Minutes from July 2, 2014: A concept review work session to discuss the proposed development project at 2 Duke St. was convened in the City Council work room.

RE: RTS Comment Response to P&Z

ROBINSON TERMINAL SOUTH-ALEXANDRIA, VA | BOARD OF ARCHITECTURAL REVIEW

NO.2 DUKE STREET PRESERVATION

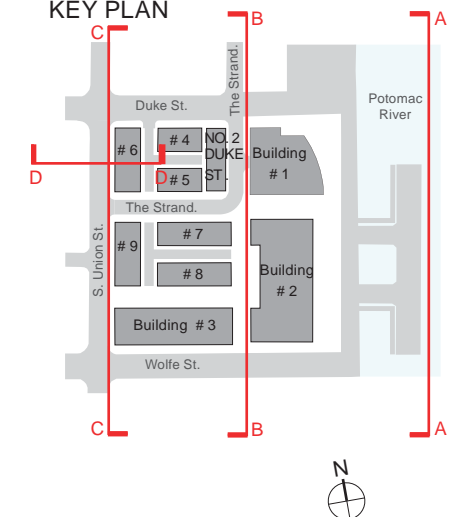
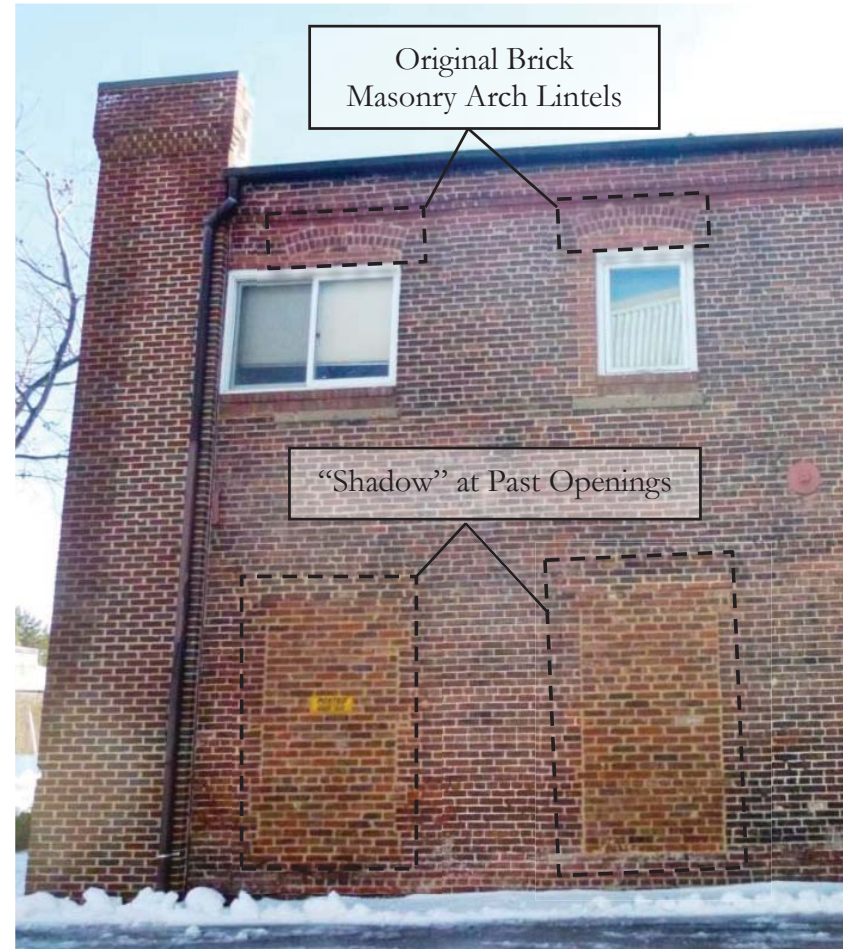
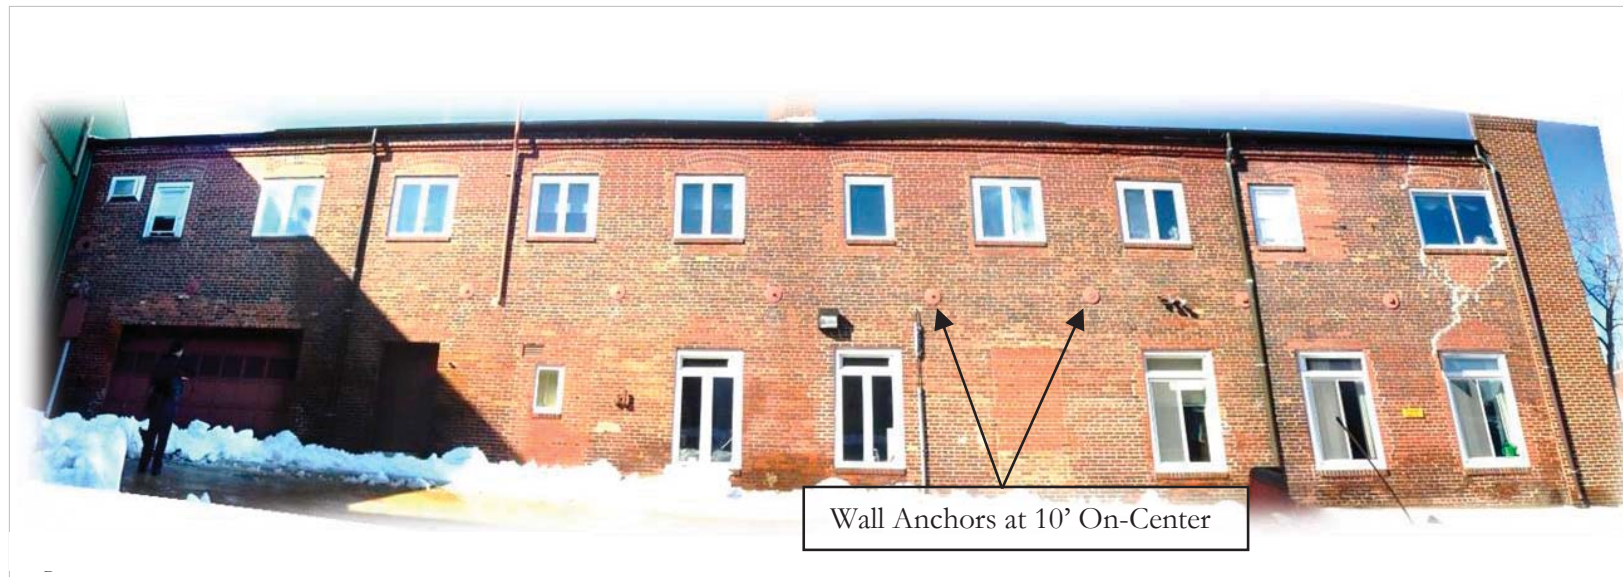
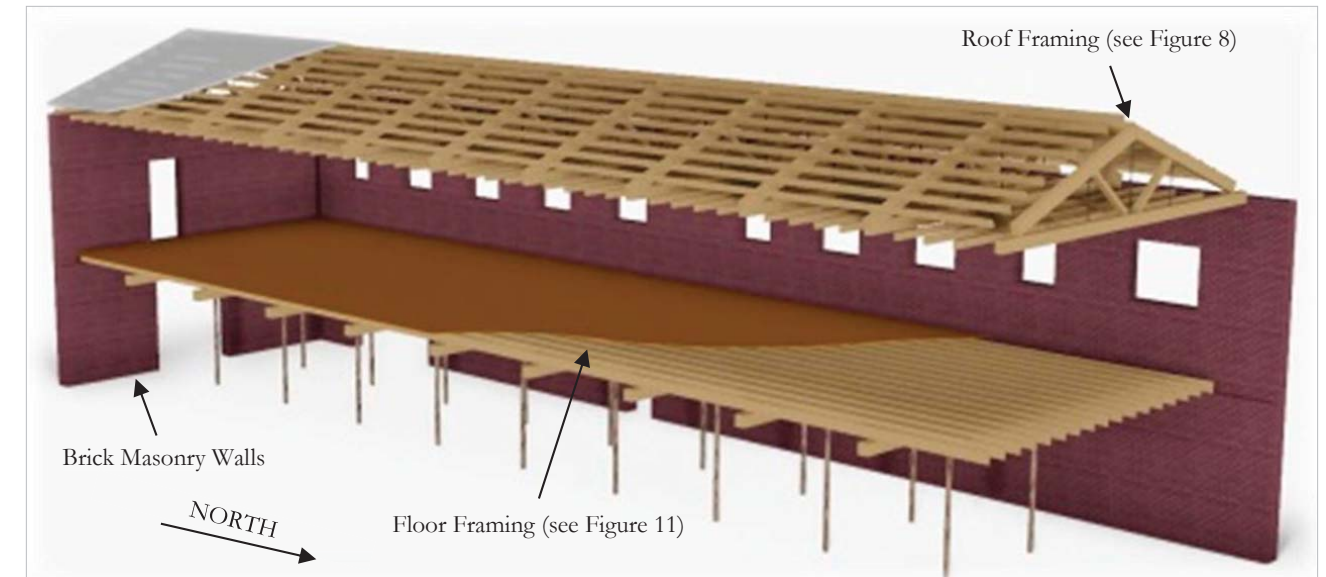
Mr. Neale thought the report and presentation helped to orient the project. Regarding 2 Duke Street, he thought it should definitely be saved but that since it was below the floodplain that it could possibly be moved to the NE section of the site. He did not think it should dictate the site planning so much and noted lots of historic buildings have been moved. He liked the east-west axis on the northern portion and recommended it be replicated on the southern portion, resulting in two allées through the site. He was troubled by the big block of building proposed on the waterfront. He did not recommend reducing the density but wanted the massing changed. He was enamored by the precedent images except for the pages of the large warehouses and noted that the Torpedo Factory was not a good precedent. He thought some of the examples were too massive. He suggested looking at the waterfront in Copenhagen which has five-story, large-scale masonry buildings with random fenestration rather than a repetitive grid. He recommended restudy of the southeastern building to increase axial transparency. He liked the nine building configuration. He thought the project had lots of potential.

A site visit to 2 Duke Street confirmed that the building still retains the original heavy timber roof trusses and framing, though the windows and north façade have been extensively modified. Staff strongly recommends that this building be retained and rehabilitated but acknowledges that alterations may be required to raise the building above the 100 year flood plain for adaptive reuse.

- 1) Respect historic structure at 2 Duke Street.
The proposed plan preserves and restores this historic warehouse in place. A program of adaptive use will implement a strategy of code compliance through sensitive alterations that will allow for contemporary commercial use while retaining significant historic fabric. Re-establishing the original building's freestanding configuration will be achieved with the removal of non-contributing additions and a landscaped space between the west façade and the proposed new construction.
- 2) Architectural Character should be compatible and contextual, but not replicative. Explore the balance between compatible and contemporary architecture. The townhouse architecture should be different from the waterfront architecture. A more modern/transparent architecture could be more appropriate for the waterfront buildings.

EYA PROPOSED PLAN

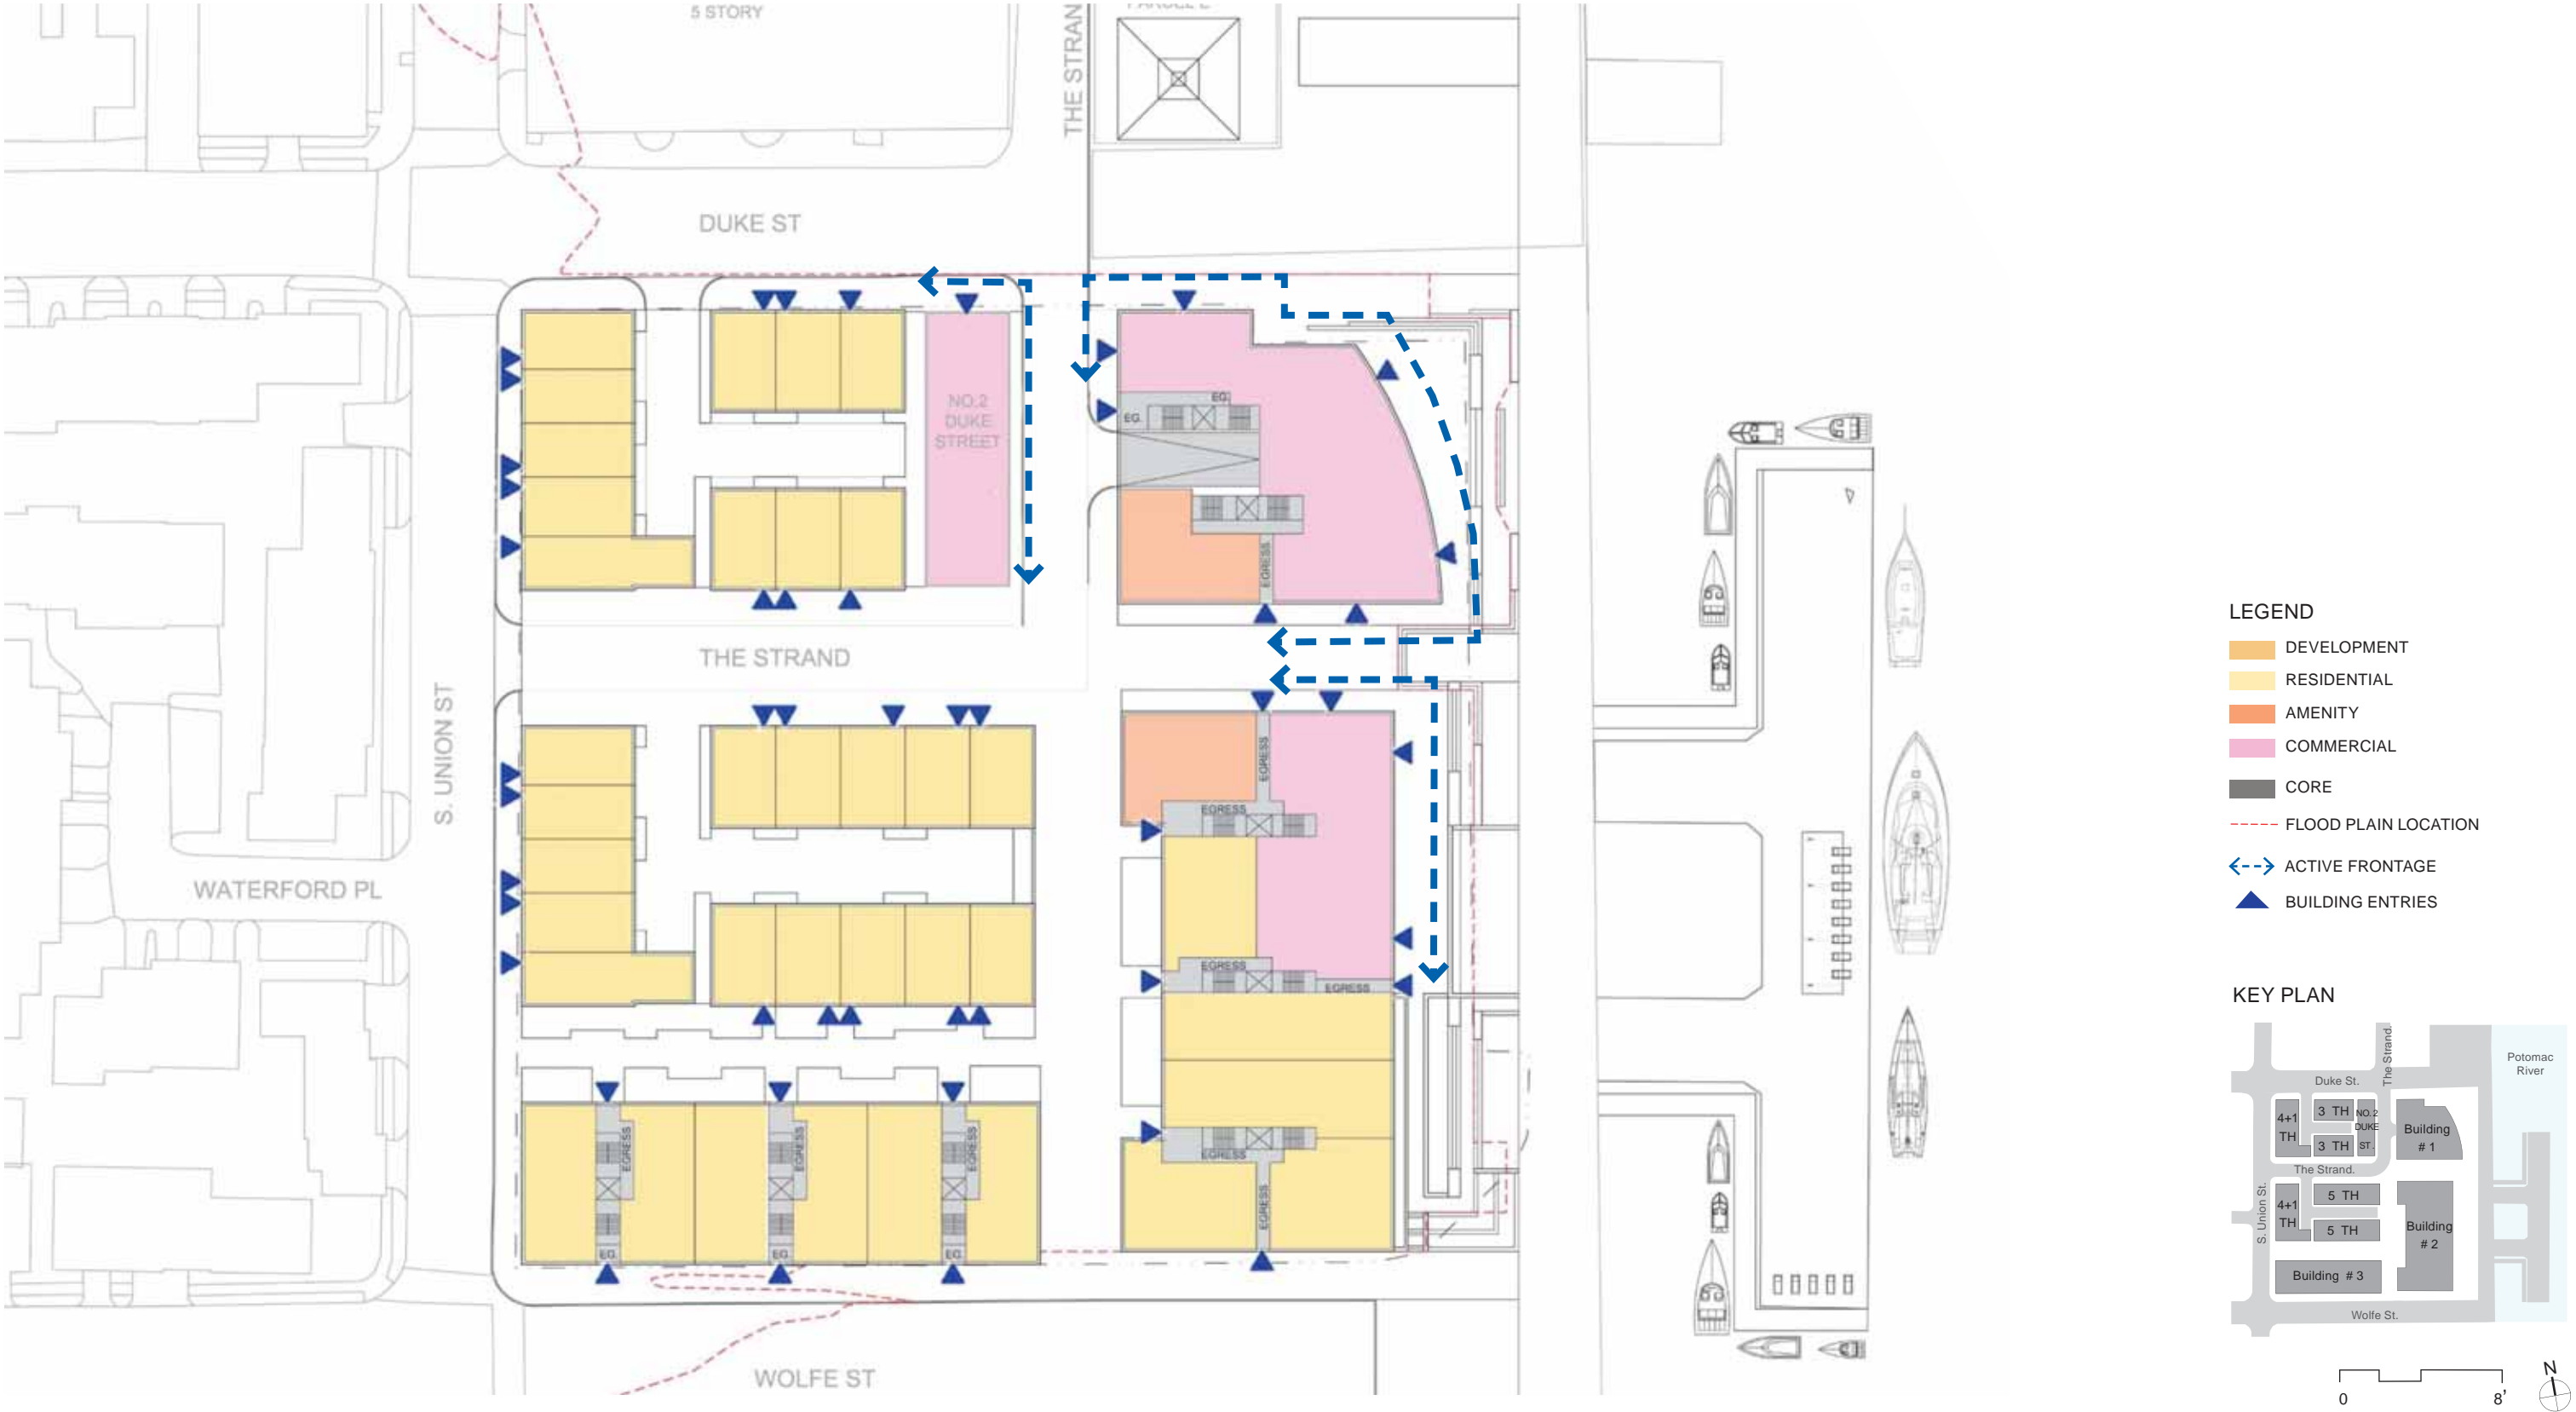
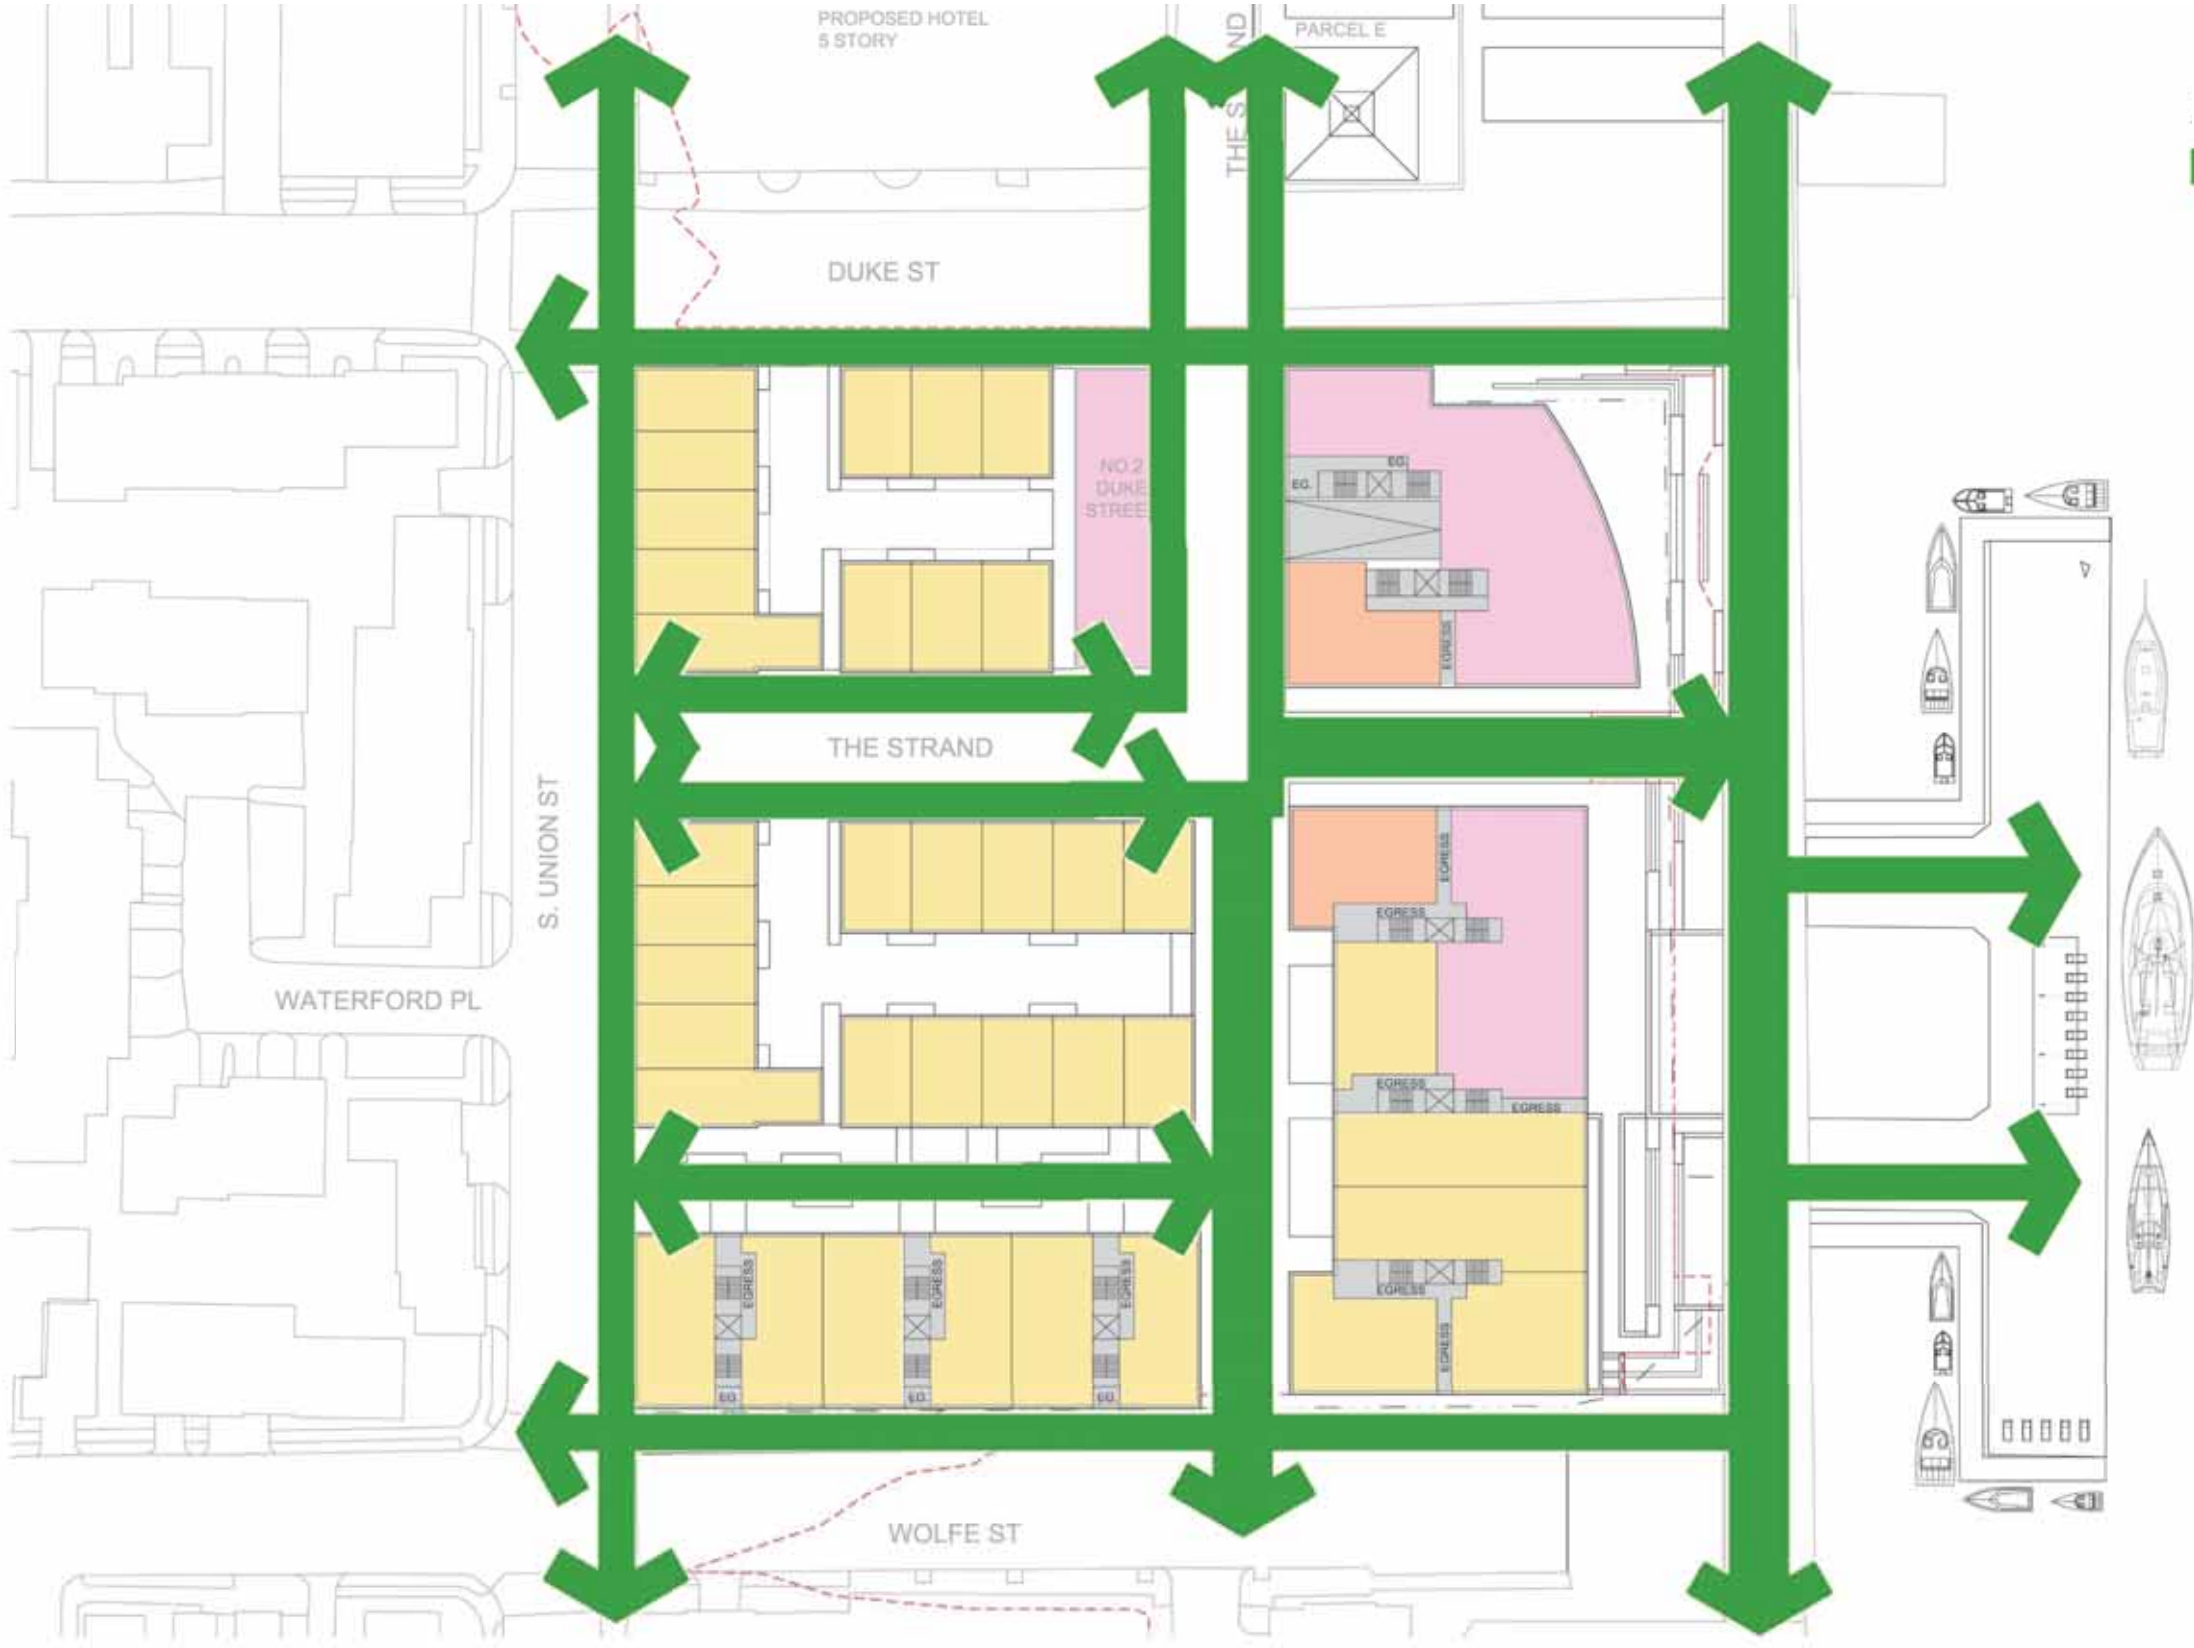
While the Board generally liked the overall site plan with a defined townhouse area and larger waterfront buildings, some Board members expressed a desire to see a second east-west alley, as well as a desire to break down the massing of the largest, southeastern, waterfront building. Staff notes that the proposed site plan provides more pedestrian connection and permeability

A study of the urban block plans north and south of the site indicate a clear pattern of major east-west streets extending to the river front with a secondary east-west alley at a third point in each block (see diagram). The proposed extension of the Strand to South Union and to the waterfront follows this pattern. A second, east-west connection at the south of the site would be an anomaly.
